Asrotex Ltd

Batjuri, Natun Bazar, Sreepur,
Gazipur, Bangladesh

23 October 2013

Problems Observed

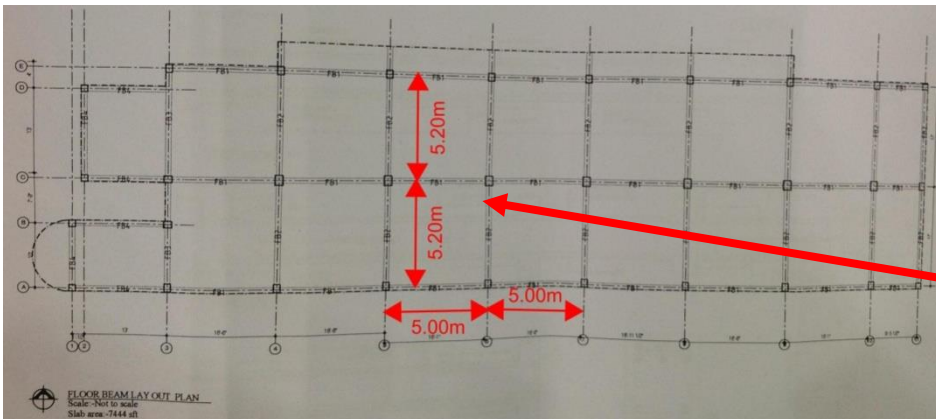
Check required on column loads and design

Column details according to drawing No. S-05

Column with brick aggregate on roof

Spans between columns

Check required on column load and design

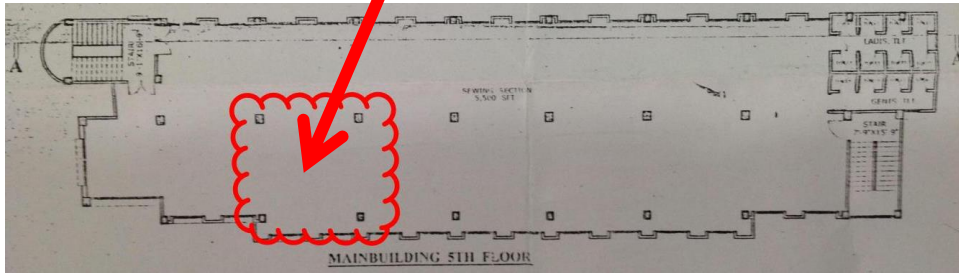
Addition of guest apartment on roof

Roof slab to be checked for taking the loading of the walls of the apartment

Addition of guest apartment on roof that does not appear on the drawings

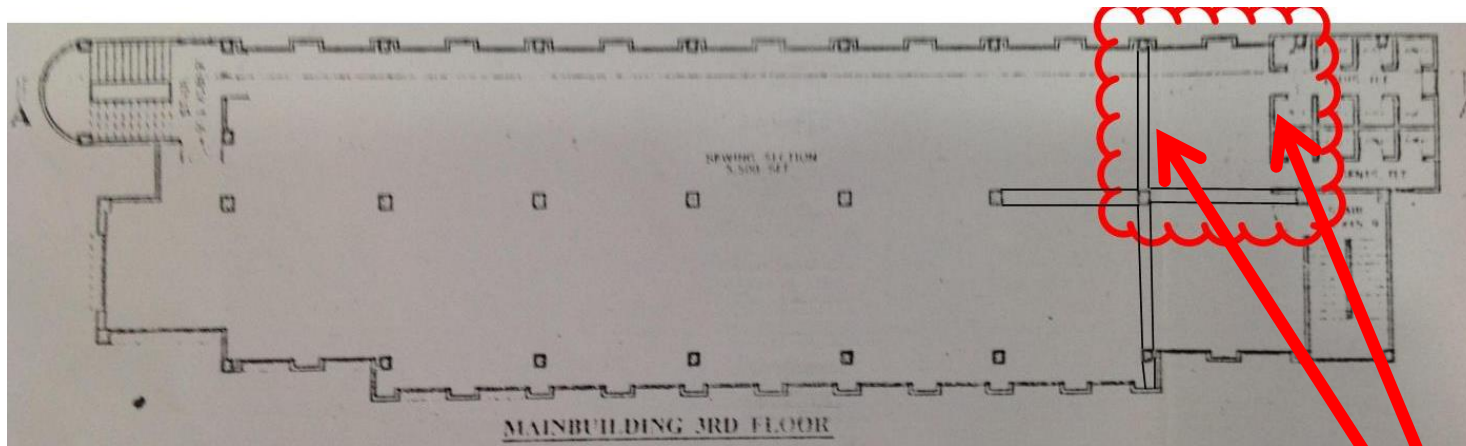
Minor cracking underside roof slab

Roof slab to be checked for maximum allowable loading and cracking investigated

Minor cracking underside roof slab (ceiling of 5th Floor space)
